**STAFF REPORT**

SUBJECT: H-2021-0039  
 Orchard Park Pad C Drive-Through – CUP

LOCATION: The site is located at 1245 W. Chinden Boulevard, approximately ¼ mile east of Linder Road (Lot 8, Block 1, Linder Village Subdivision), in the NW ¼ of the NW ¼ of Section 25, Township 4N., Range 1W.

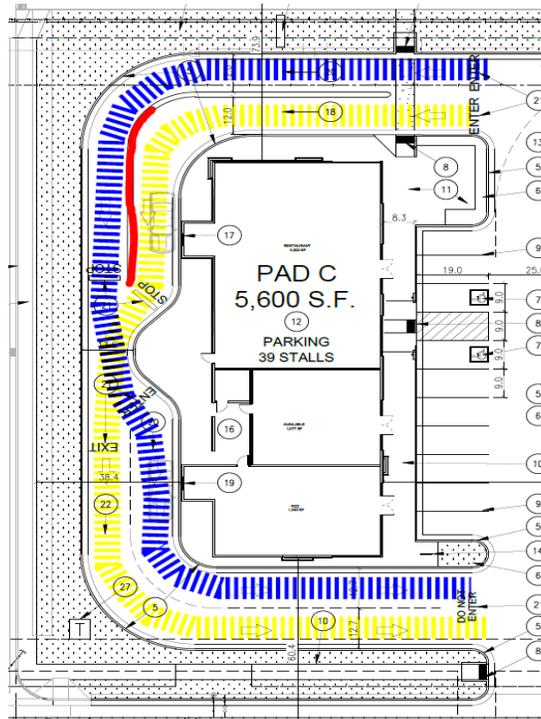
The Applicant provided a circulation plan that shows the intended traffic patterns and Staff agrees with the proposal but with some minor recommended revisions. The submitted plan shows Tenant “A,” the north tenant, as utilizing the yellow path which includes the southern drive-through at the north side of the building. Once a customer orders along the north side of the building they continue to the west side of the building and pick-up their order. They then stop at the determined drive-through crossing and go from being the inside lane to the outside lane to exit the drive-through at the south end of the site. After this crossing point, the yellow lane (the outside lane) becomes the escape lane which is required for the length of the drive-through lanes. Tenant “B” utilizes the blue path according to the submitted site/circulation plan and essentially follows the opposite path of Tenant A. For Tenant B, the entrance along the north side of the building is the stacking lane and order position. Once customers for this tenant order and then stack at the determined crossing point, they would cross

from the outside lane to the inside lane to pick-up their order. After pick-up, customers would continue south to turn east around the south side of the building and exit the drive-through.

The proposed drive-through design is uncommon and complex with the added crossing point. Staff finds that with adequate signage and striping the proposed drive-through can work. Therefore, Staff is recommending not only striping on the pavement but also signage at the entrances and along the drive-through lanes to ensure customers know which business they are in line for. The proposed signage and striping should be submitted with the future CZC and DES applications for the building should it receive CUP approval for the drive-throughs. In addition, the north half of the proposed drive-throughs show a curbing of some kind that separates the two lanes. Staff understands the purpose of this but finds that a portion of it should be removed to allow for customers to use the outside lane as an escape lane earlier in the drive-through. See area noted below in red:

3. The site plan submitted with the future Certificate of Zoning Compliance application shall be revised as follows:
  - a. Per the exhibit within Section V above, remove a segment of curbing within the north half of the separated drive-throughs.

**A. Proposed Site Plan (dated: 4/09/2021)**

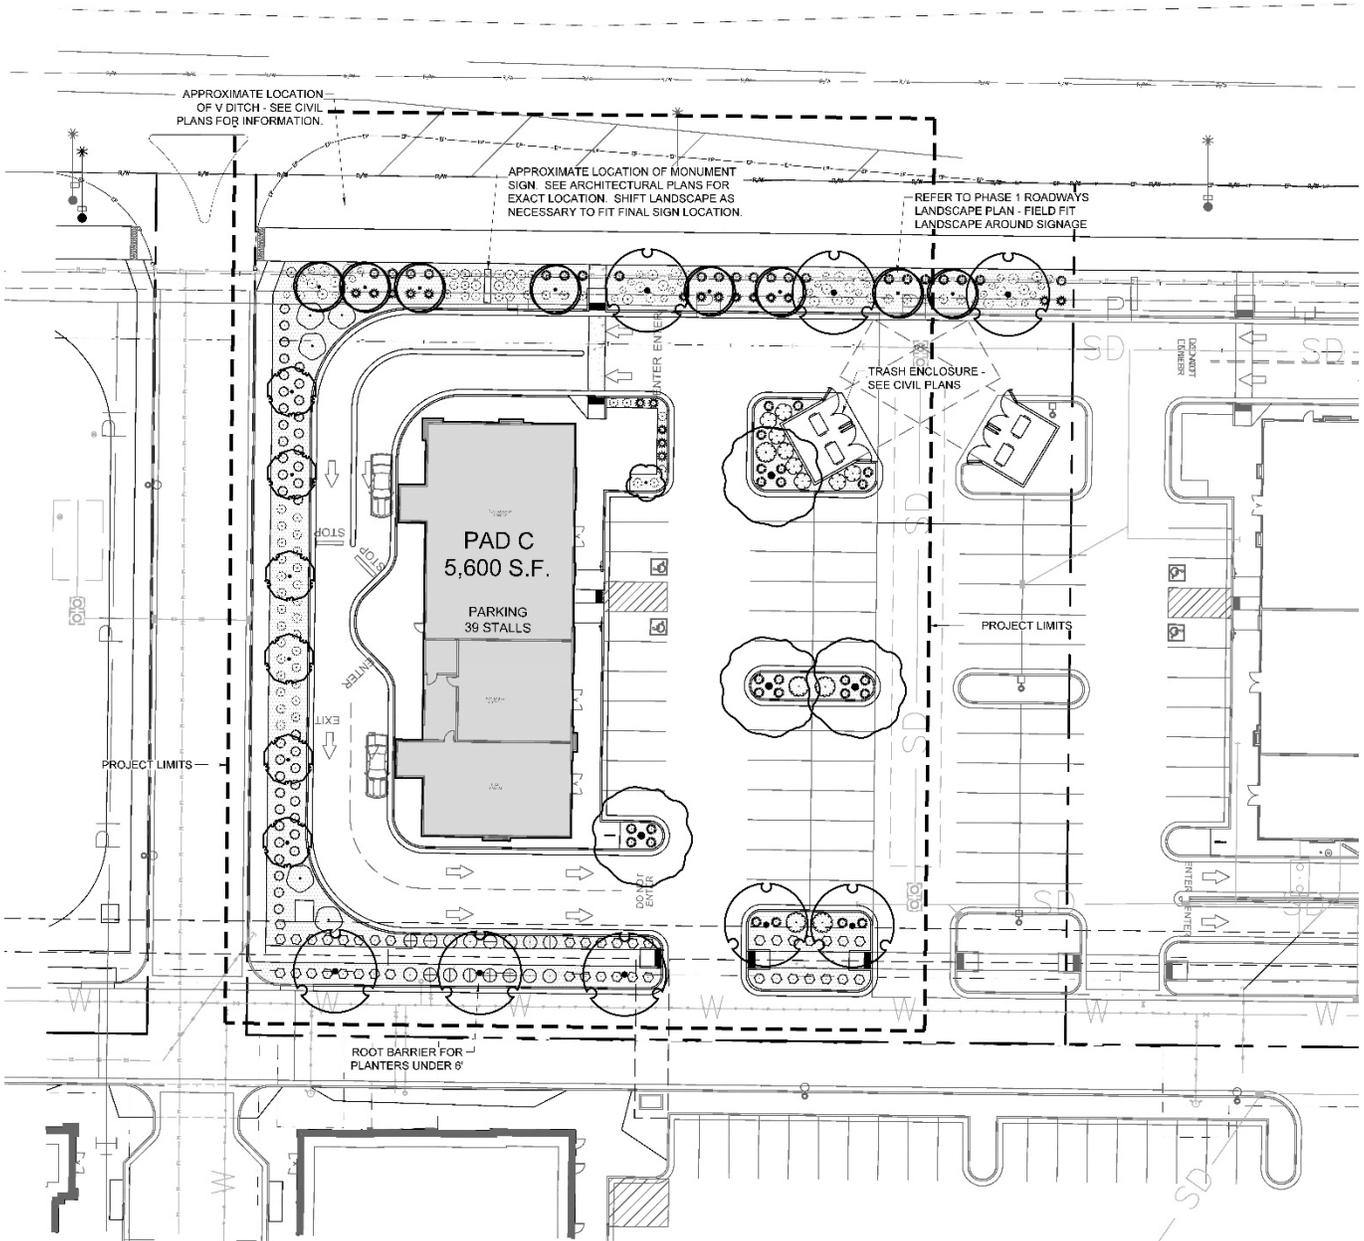
The submitted site plan shows a rectangular building situated to the west portion of the buildable site area and is proposed with 36 new parking spaces—the shared parking area between the two multi-tenant buildings will have at least 74 parking spaces; code requires a minimum of 44 spaces. The site plan shows two two-way drive aisles to the east of the building with parking adjacent to both drive aisles. These drive aisles connect to the east-west drive aisle closest to Chinden Boulevard that is the entrance to the proposed drive-throughs. Because the drive-throughs serve two separate tenants, the traffic patterns for each cross over one another midway through the site along the west side of the building.

*Per the submitted site plan, no public right-of-way has direct access to the site so there is no possibility for stacking to impede public ROW. The stacking lanes for each drive-through vary in length but both entrances are at the north end of the site and begin at the west end of the northernmost east-west drive aisle. Based on an exhibit (Exhibit VII.C) provided by the Applicant, the two ordering locations appear to be approximately 65 feet into the drive-through lanes. This should allow for 3-4 cars stacking prior to getting to the menu boards; if more cars stack in either lane, they will impede the east-west drive aisle along the north boundary of the site. Staff does not foresee the proposed businesses requiring extended stacking lanes like that of a Dutch Bros. or other solitary coffee shop. However, Staff recommends moving the menu boards further into the drive-through lanes to help alleviate the potential of this conflict. The north drive-through can move the menu board and order speaker at least 10 feet to the west with no foreseeable issues. The internal drive-through lane does not have as much room but should be able to move them at least 5 feet further west; any additional distance is a benefit.*

*The stacking lane for at least one of the proposed drive-through lanes appears to be greater than 100 feet in length. As noted, Staff is unaware of where the ordering location is on the submitted site plan but it appears to be along the north end of the site for both lanes. With this assumption, the stacking lane for the overall drive-through is long enough to require an escape lane. As discussed previously, the outside lane is the escape lane following the crossing point of the two drive-throughs. Staff finds the proposed escape lane layout complies with this requirement. To ensure that the outside lane can be better utilized as an escape lane earlier in the drive-through process, Staff is recommending a section of curbing shown on the site plan at the north half of the site is removed (see exhibit above in previous section).*

The proposed use of a Restaurant is subject to an additional specific use standard listed in UDC 11-4-3-49 and notes that the minimum amount of parking shall be one (1) space for every 250 square feet of gross floor area. *Based on the proposed building size of 5,600 square feet noted on the submitted site plan, a minimum of 22 parking spaces are required. The proposed site plan shows 36 parking spaces, exceeding UDC minimums. In addition, this building shares a larger parking area with an identical building to the east with an overall parking count of 74 spaces between the two sites, exceeding the minimum amount required by code by 30 spaces. At the time of the future Certificate of Zoning Compliance (CZC) application, the data table on the site plan should be corrected to reflect the correct minimum standards of a restaurant use instead of the general commercial ratio.*

**Parking:** A minimum of one (1) parking space is required to be provided for every 250 square feet of gross floor area for the proposed restaurant use. *The proposed building is shown as 5,600 square feet requiring a minimum of 22 parking spaces; the submitted site plan shows 36 proposed parking spaces in addition to other shared parking spaces to the east, exceeding UDC minimums. All proposed drive aisles and parking spaces also meet the required dimensional standards.*

A minimum one (1) bicycle parking space is required to be provided for every 25 vehicle spaces or portion thereof per UDC [11-3C-6G](#); bicycle parking facilities are required to comply with the location and design standards listed in UDC [11-3C-5C](#). *Bicycle parking is shown on the submitted plans in compliance with code (noted as callout number 14 on the site plan).*

**Pedestrian Walkways:** A pedestrian walkway is depicted on the site plan from the proposed building entrance sidewalk to the multi-use pathway along W. Chinden Blvd. as required by UDC 11-3A-19B.4a. This walkway is depicted to traverse both entrances of the drive-through lanes which introduces a known conflict between pedestrians and vehicles. *Therefore, Staff is recommending this walkway be distinguished from the driving surface by being constructed with pavers, brick, or scored/colored concrete, per subsection B of this code section. The proposed site plan appears to show a different material than the drive surface but its material is not called out. The Applicant should confirm compliance with this code section with a future CZC submittal and note the proposed material for this walkway.*

2. The Conditional Use Permit for the proposed Drive-Through Establishment is hereby approved with the following conditions of approval:
  - a. The proposed menu boards/order speakers shall be located no less than 65 feet from the near edge of curb at the drive-through entrances. Compliance shall be depicted with the Certificate of Zoning Compliance site plan.

- b. **The Applicant/Owner shall include both pavement striping and signage throughout the site and within the drive-throughs to ensure traffic circulation pattern is clear to patrons; proposed signage AND striping locations shall be submitted and depicted on the site plan at the time of Certificate of Zoning Compliance application and include both directional and tenant signage to direct patrons to desired tenant drive-through.**

- c. Per UDC 11-3A-19B.4b, depict all pedestrian walkways traversing driving surfaces to be constructed with bricks, pavers, and/or colored or scored concrete to clearly delineate the driving surface from the pedestrian walkway.

- b. Provide exhibits of and depict on the plans the striping and directional and tenant signage
4. The submitted landscape plan is approved as submitted. Applicant shall maintain the required 35-foot landscape buffer to Chinden Boulevard per City standards outlined in UDC 11-3B-7.

B. Proposed Landscape Plan (dated: 4/08/2021)

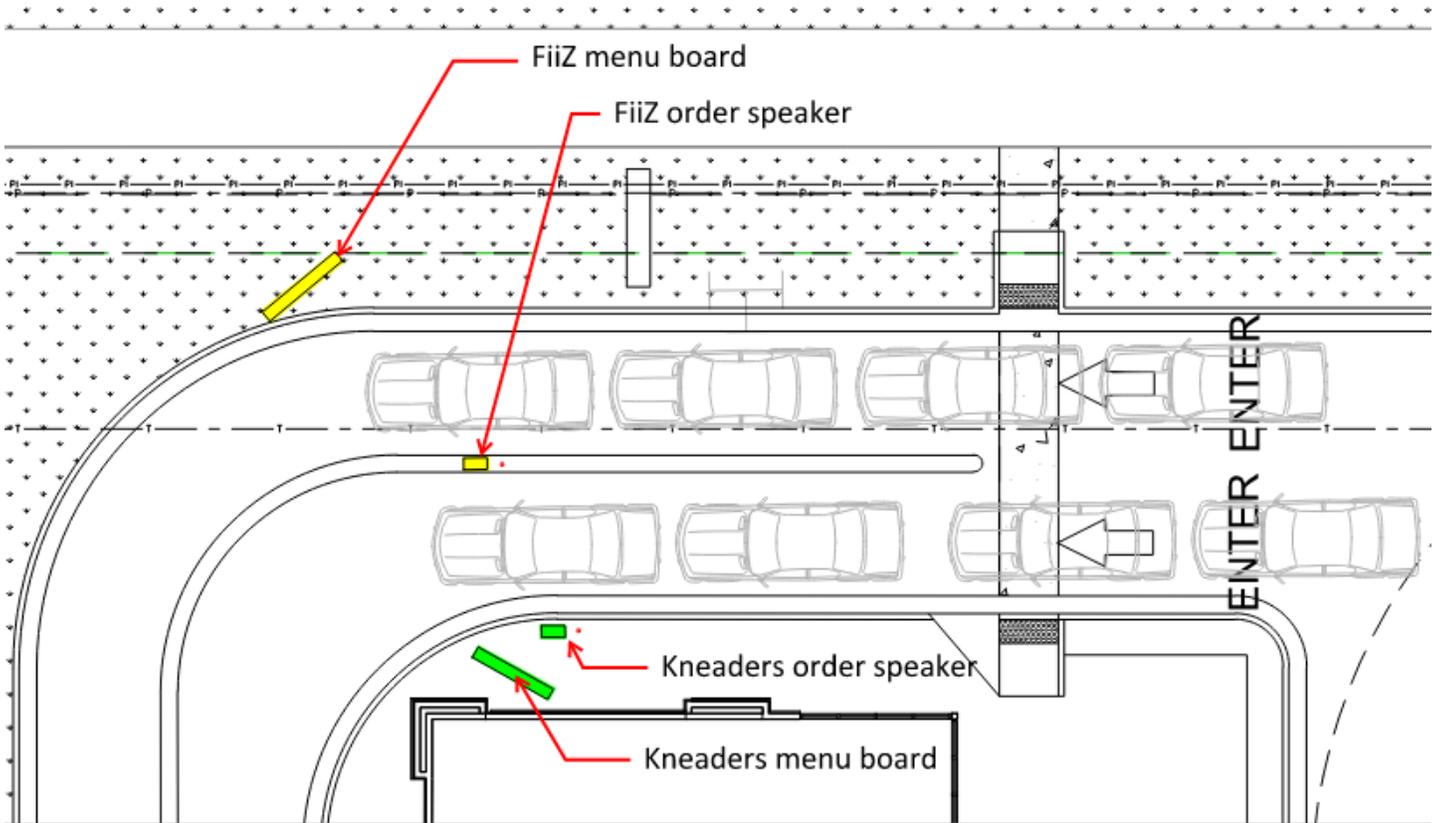
A minimum 5-foot wide landscape buffer is required to be provided along the perimeter of the parking or other vehicular use areas as set forth in UDC 11-3B-8C.1. *The proposed parking drive aisles and drive-through around the perimeter of the subject site are proposed with landscaping at least 10 feet wide and vegetated with appropriate trees, shrubs, and other vegetative ground coverage. Staff finds these areas and proposed sidewalks meet and exceed the minimum landscape requirements. Furthermore, the submitted landscape plan shows all adjacent parking spaces with the required planter beds and landscaping.*

C. Proposed Menu Board and Order Speaker Locations

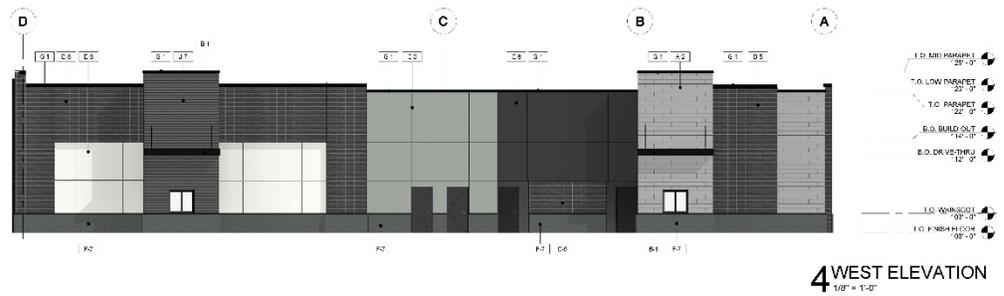
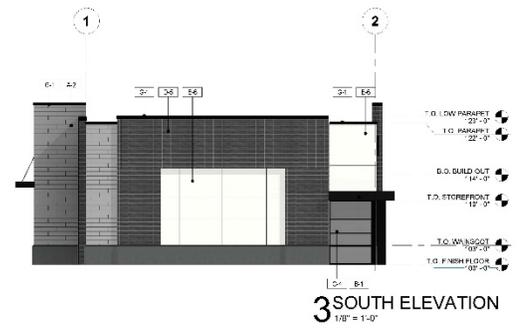
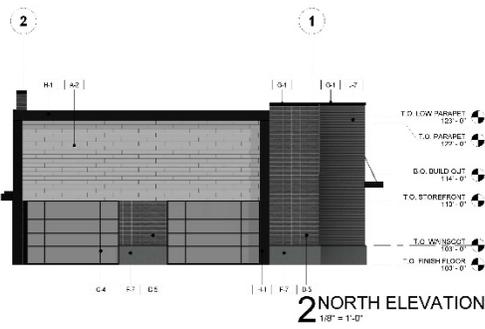
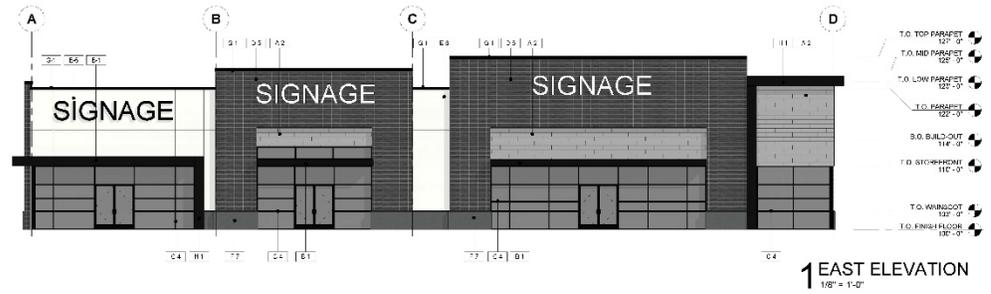
*Again, Staff does not foresee stacking for the proposed businesses being an existential crisis but understands the concern and has thus made minor recommendations to help with the potential problem. At a minimum, Staff is recommending the distance from the start of the drive-through to the order speakers shall be no less than 65 feet to ensure at least this distance is maintained.*
